Magnolia Public Schools

Ad-Hoc (Facility) Committee Meeting

Approval of Change Order Requests by Oltmans Construction Co. for MSA-1

Ad Hoc Committee Agenda Item #:	II A – Action Item
Date:	January 23, 2020
To:	Magnolia Educational & Research Foundation dba Magnolia Public Schools (“ MPS ”) Ad Hoc Committee (the “ Committee ”)
From:	Alfredo Rubalcava, CEO & Superintendent
Staff Lead:	Patrick Ontiveros, General Counsel & Director of Facilities
RE:	MSA-1 Change Order Requests

Reference 2/A5.1 & submittal#06100-02

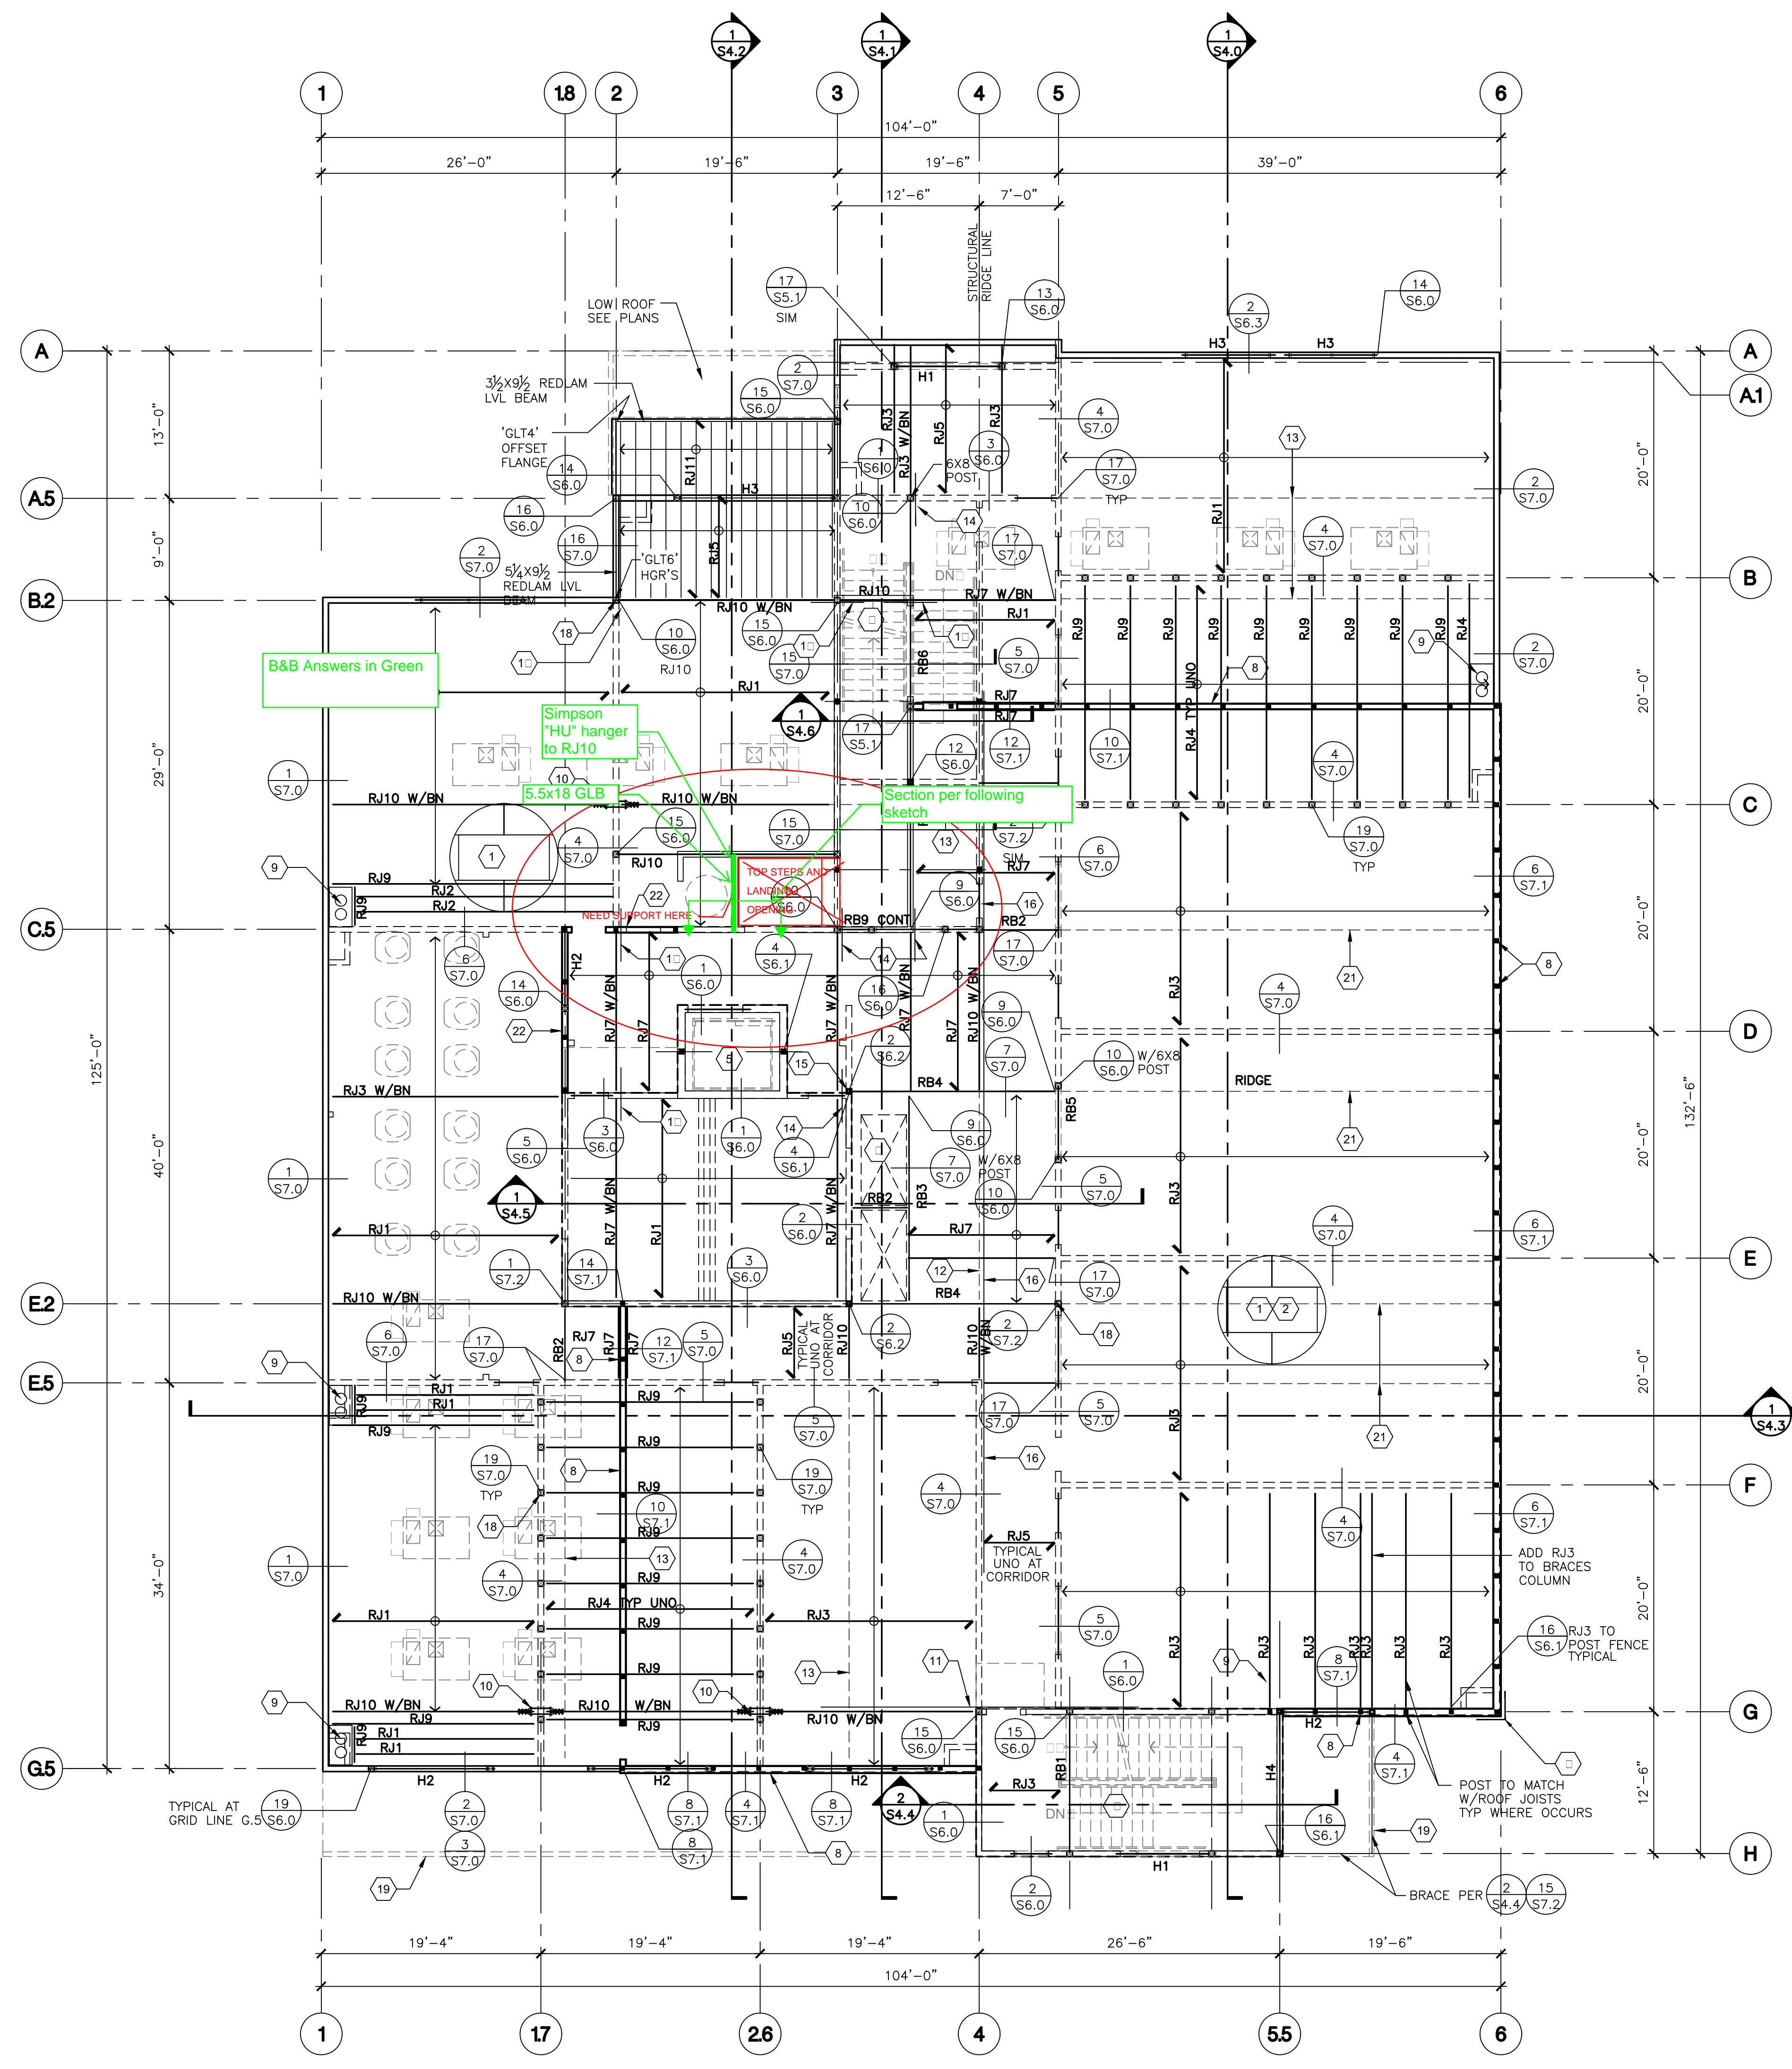
Stair #1 has an issue at the top. The top landing and the existing Red Built TJI's are trying to occupy the same space. Johann reviewed on site. Please make recommendations. I would suggest the TJI be cut back and hung off a beam. Fill in under the stair pan with shorter lumber. Perhaps 2 x 8 lumber.

Suggestion:**Answer:** **Accept Suggestion**

Co-Author RFI Number: 6/S7.1 Strap

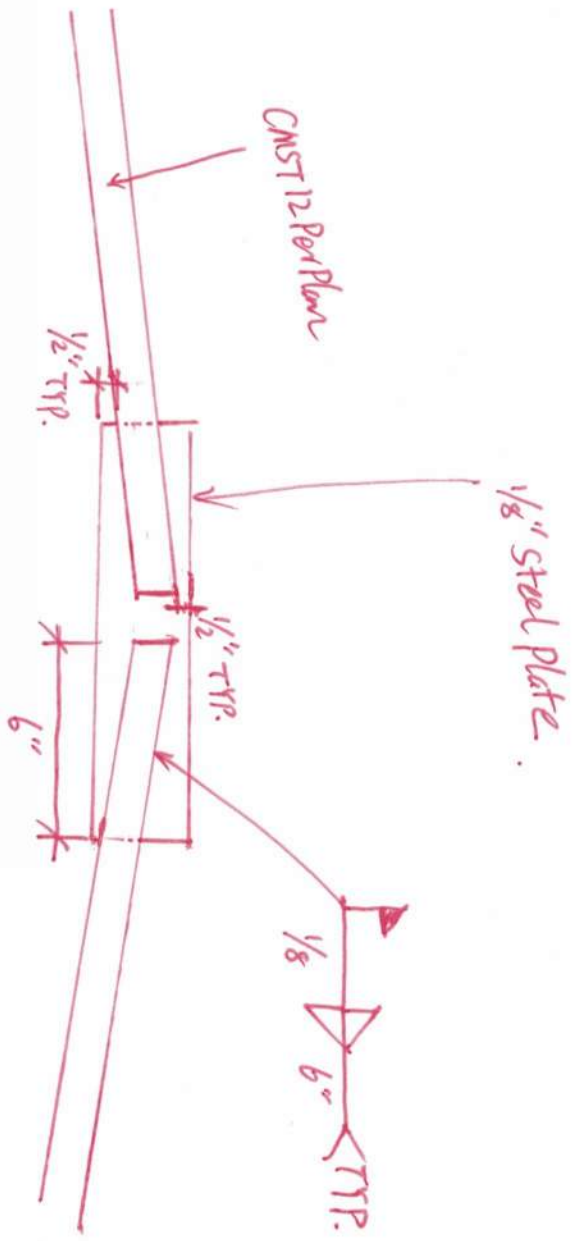
Sheet S 7.1 detail 6 calls out for a CSMT 12 strap, see attachment, this strap cannot be installed on the side of the top plate due to the required roof pitch. The strap cannot be bent to match the pitch. Please advise.

Splice at the strap turning point with 1/8" steel plate with 1/8" x 6" long welding at top and bottom of each strap end.
Please see the attached sketch.
